YUCCA MOUNTAIN – SUPPLEMENTAL RESPONSE – REQUEST FOR ADDITIONAL INFORMATION (RAI) –VOLUME 2, CHAPTER 2.1.1.4, SET 3 (DEPARTMENT OF ENERGY'S SAFETY ANALYSIS REPORT SECTION 1.7) – Identification of Event Sequences

RAI Volume 2, Chapter 2.1.1.4, Third Set, Number 1, Supplemental Question 5:

RAI Volume 2, Chapter 2.1.1.4, Third Set, Number 1, Supplemental Question 7:

Figure 1. Subsurface Repository Intake and Access Mains

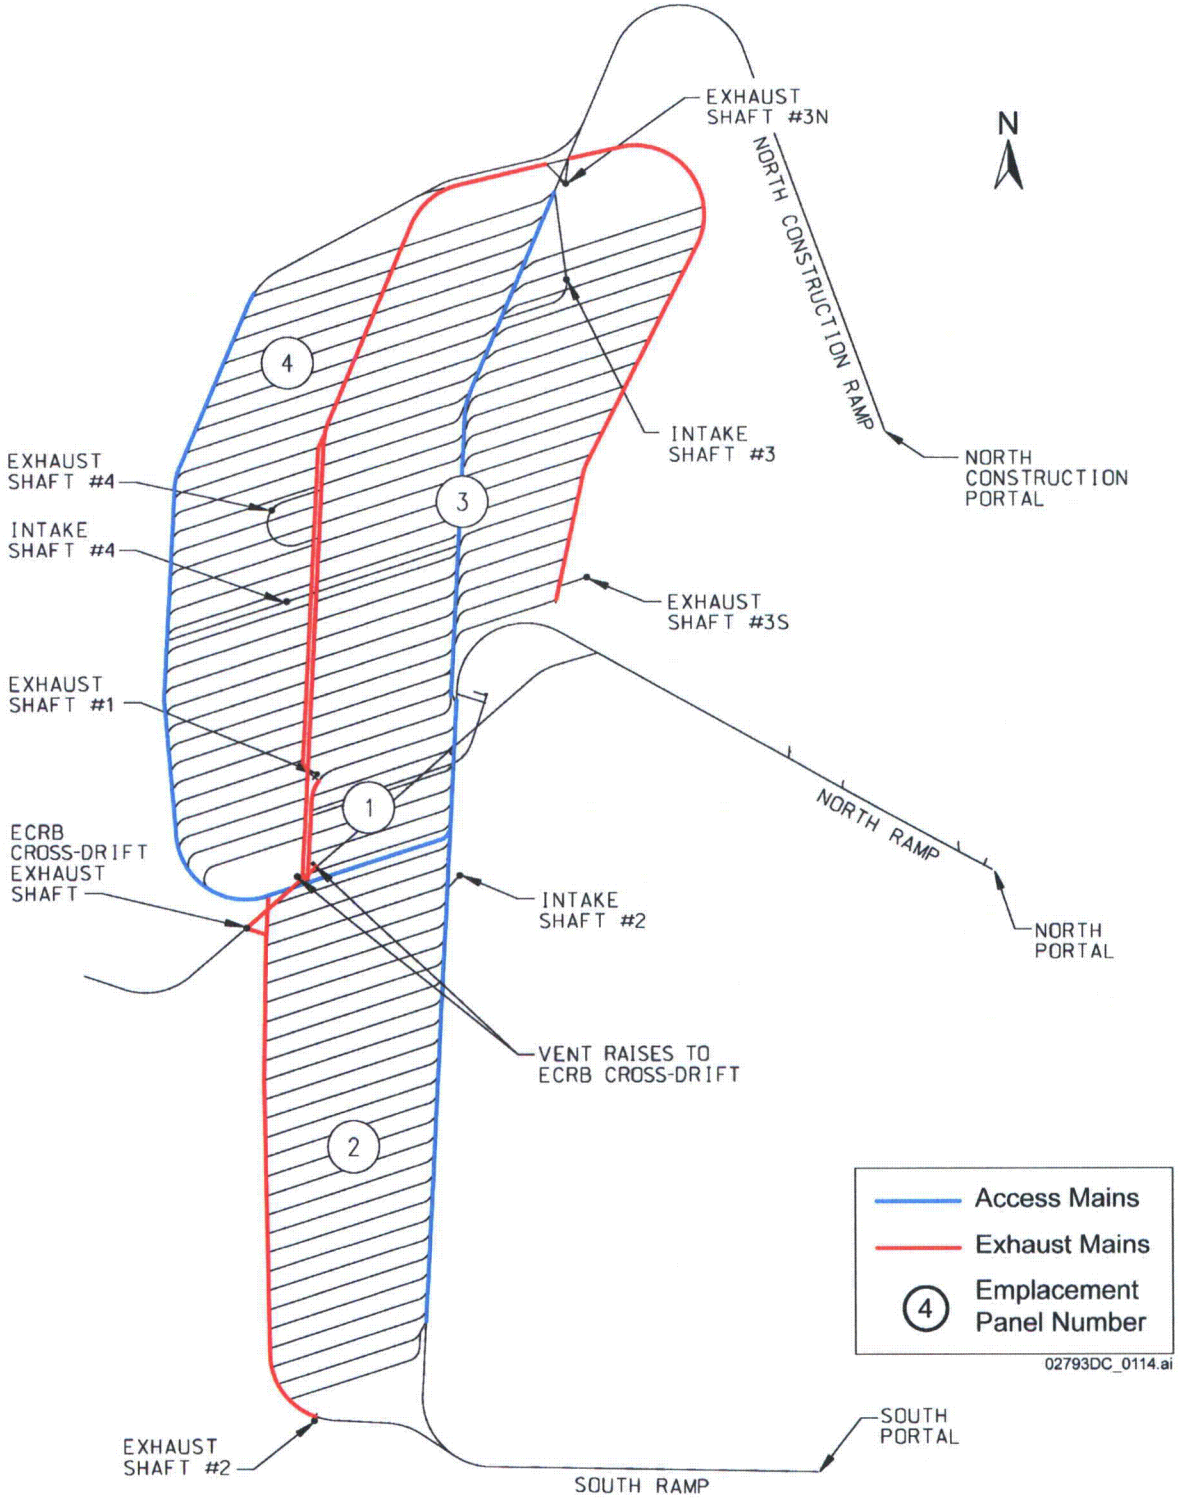
Clarify the DOE's plan for ensuring sufficient air flow through the ventilation exhaust system if one or more openings used for exhaust air flow (e.g., on exhaust main or shaft) were to be blocked due to rock collapse.

The underground layout configuration is a modular design that provides flexibility to meet thermal goals (SAR Section 1.3.1.2.5), and provides the capability for alternate ventilation airways using the existing openings, should one of the airways fail. Exhaust shafts have been positioned at the ends of each panel, except in Panel 1, to provide for diversion of the airflow if required (Figure 1). The subsurface layout ventilation components, consisting of three shafts and three ramps on the intake side and six shafts on the exhaust side, provide a minimum of 20% extra capacity overall (BSC 2003, Section 8.6).

Fully Emplaced Repository—Except for Panel 1, the design of the subsurface layout provides for multiple exhaust shafts in each emplacement panel, which are typically located at the northern and southern ends of each panel. In addition, the exhaust airway drifts are interconnected where possible and the shaft access drifts are designed to accommodate airflows from different sources (Figure 1). For example, the Panel 3 and Panel 4 Exhaust Main is a continuous excavation with Exhaust Shaft #3N configured to exhaust air from Panels 3E, 3W, and 4. Exhaust Shaft #3S provides a second exhaust airway at the south end of Panel 3E. Exhaust Shaft #4 is configured to exhaust air from Panels 3W and 4, and the Enhanced Characterization of the Repository Block (ECRB) exhaust shaft can exhaust air from Panels 1, 2, 3W, and 4. The Panel 2, 3W, and 4 exhaust airflow paths are connected via the ECRB cross-drift and internal raises.

Initial Emplacement for Panel 1—The initial emplacement will occur in Panel 1, in the central part of the overall subsurface layout. Exhaust Shaft #1 is the only exhaust source for initial emplacement in Panel 1, and in the event that Exhaust Shaft #1 is unavailable during the initial development and emplacement phase, the ECRB exhaust shaft could be reconfigured as the alternate exhaust airflow route. The ECRB exhaust shaft is constructed prior to initial waste emplacement to provide intake air to the second phase of construction via an internal raise (SAR

Figure 1.3.5-15). Because the failure of Exhaust Shaft #1 would be an off-normal event, and no readily available second exhaust airflow route is available, the ECRB exhaust shaft and selected isolation barriers in the Panel 1 area would need to be reconfigured (addition of bulkheads) to redirect exhaust airflows. Such changes can be made in a reasonable period of a few days without detrimental thermal impacts.

Figure 1. Peak Midpillar Temperature (°C) Over Each Seven-Waste-Package Segment for the Estimated Limiting Waste Stream.

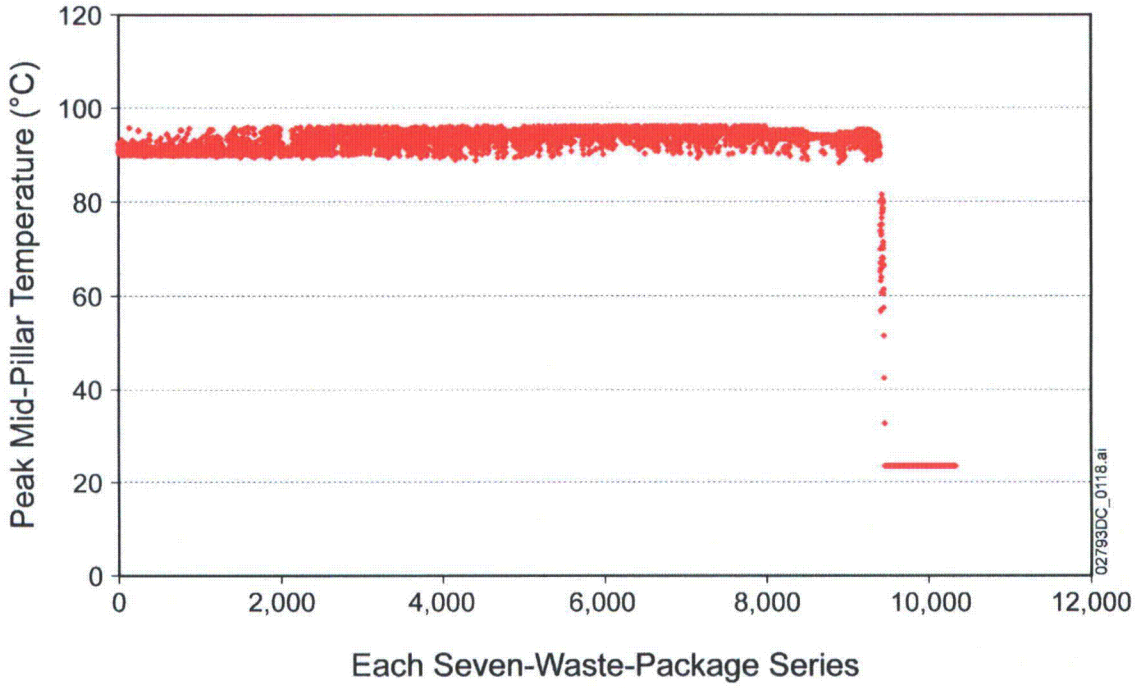
To clarify DOE's plan to ensure sufficient ventilation of waste packages to meet repository thermal limits, provide documentation that shows the calculations and methodology to obtain local and overall average thermal line loads, in enough detail to enable a review of the estimated limiting waste stream average line load in SAR Figure 1.3.1-6.

To evaluate the range of local average thermal line loads in the repository, emplacement of the estimated limiting waste stream in the subsurface was simulated by using a postprocessing algorithm for the total system model output. For this purpose, an index of thermal energy density was developed specific to each commercial SNF and codisposal waste package, and the waste packages were emplaced so that a running average of this index was less than a prescribed limit (SNL 2008, Section 6.1.3). The thermal energy density for a single waste package is that thermal energy content that results in the peak midpillar temperature if the entire repository was loaded with waste packages with identical thermal decay histories, and is therefore described in terms of the midpillar temperature. The running average is then an estimate of the local peak midpillar temperature, calculated with the thermal energy densities for all the waste package types represented in a given drift segment. As stated in SAR Section 1.3.1.2.5, approximately half of the individual waste packages in the estimated limiting waste stream have an index of thermal energy density that exceeds the limit of 96°C. Therefore, those waste packages must be emplaced with, and proximal to, cooler packages so that the estimated local peak midpillar temperature is 96°C or cooler based on a running average over a seven-waste-package segment.

The postprocessing algorithm for the total system model kept track of the commercial SNF delivered to the repository and placed into surface storage for either fuel staging or aging, and then, at each loading opportunity, selected the waste package giving a running average value closest to the 96°C limit. Two other constraints were also imposed on commercial SNF waste package segments to control preclosure temperatures in the event of temporary loss of forced ventilation, as follows (SAR Section 1.3.1.2.5):

The emplacement drifts were loaded with waste packages, one at time, yielding a sequence of more than 10,000 waste packages that was examined to find the hottest seven package segments (SNL 2008, Section 6.1.4). The maximum local average thermal line load of 2.0 kW/m at

NOTE: Data entries (dots) in the figure represent the calculated midpillar temperatures for the series of seven-waste-package segments, with the waste package segments being incremented one waste package at a time. The estimated limiting waste stream contains a total of 10,324 waste packages (BSC 2007c, Case 3b in Table 12).

The drop in midpillar temperatures towards the end of the series is due to the fact that the hotter, commercial spent nuclear fuel waste packages comprising the estimated limiting waste stream and a major portion of the cooler, noncommercial waste packages are emplaced in the earlier years, and the remaining cooler, noncommercial waste packages are emplaced in the later years of emplacement. Hence, the estimated limiting waste stream is conservative from a thermal loading perspective than what the actual emplacement mode would be (i.e., emplacing the cooler noncommercial waste packages with commercial spent nuclear fuel waste packages as the noncommercial waste is made available to the repository).
